UNITED STATES PATENT AND TRADEMARK OFFICE

APPLICATION NO.	FILING DATE	FIRST NAMED INVENTOR	ATTORNEY DOCKET NO.	CONFIRMATION NO.
10/670,594	09/25/2003	Roy Lee Hayford	60130-1407; 02MRA0185	7491

DETAILED ACTION

Exhibit A

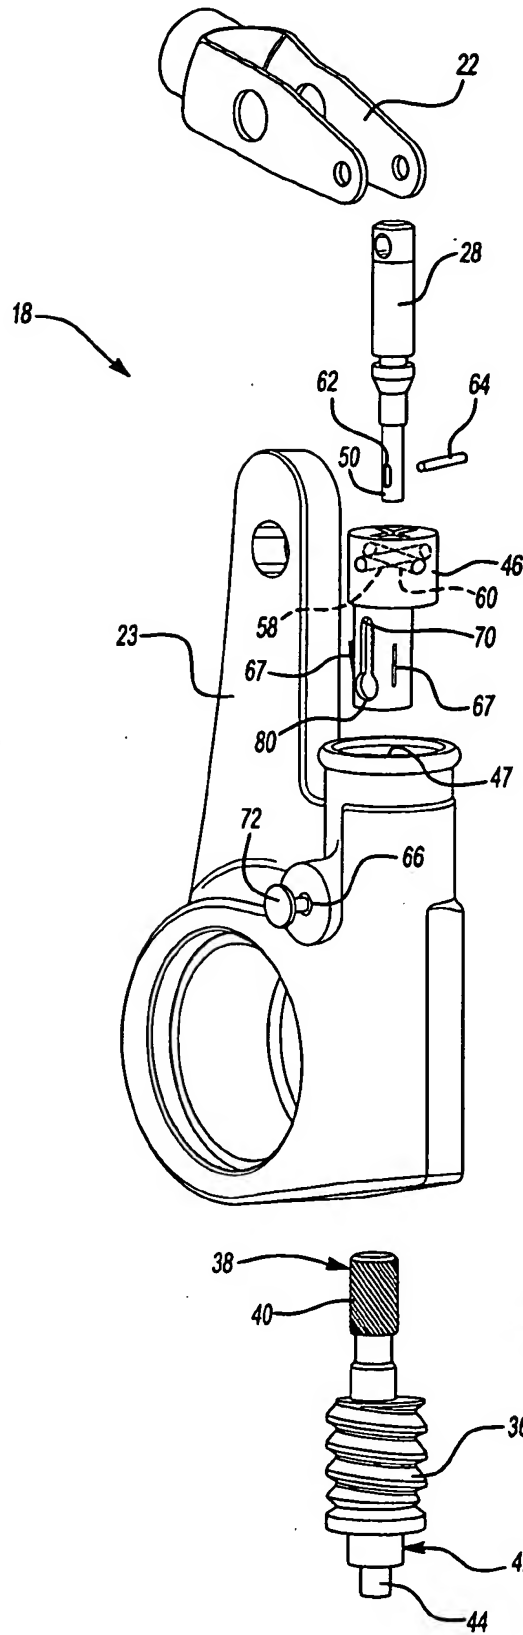
3. The drawings are objected to under 37 CFR 1.84(h)(5) because Figure 2 filed on 6/17/05 is completely different from figure 2 originally filed. The drawings show(s) modified forms of construction in the same view. Examiner has attached copies of both figure 2 replacement and figure 2 original. Corrected drawing sheets in compliance with 37 CFR 1.121(d) are required in reply to the Office action to avoid abandonment of the application. Any amended replacement drawing sheet should include all of the figures appearing on the immediate prior version of the sheet, even if only one figure is being amended. The figure or figure number of an amended drawing should not be labeled as "amended." If a drawing figure is to be canceled, the appropriate figure must be removed from the replacement sheet, and where necessary, the remaining figures must be renumbered and appropriate changes made to the brief description of the several

9. Applicant's arguments filed 10/26/05 have been fully considered but they are not persuasive. Lavelly reads on the limitations as amended in claim 18 and as recited in new claim 20 as set forth above. Accordingly, the rejections have been maintained. Examiner recommends incorporating the language --including a slot that is elongated in a direction generally parallel with said axis-- in lines 7-8 of claim 18 to preclude the use of the dimensions of the diameter of the slot of Lavelly. Examiner also notes that the drawing objection of the previous office action is maintained since the replacement sheet of figure 2 filed 6/17/05 appears to be completely different from that originally filed. See exhibit A – originally filed figure 2 and exhibit B – replacement figure 2 filed 6/17/05.
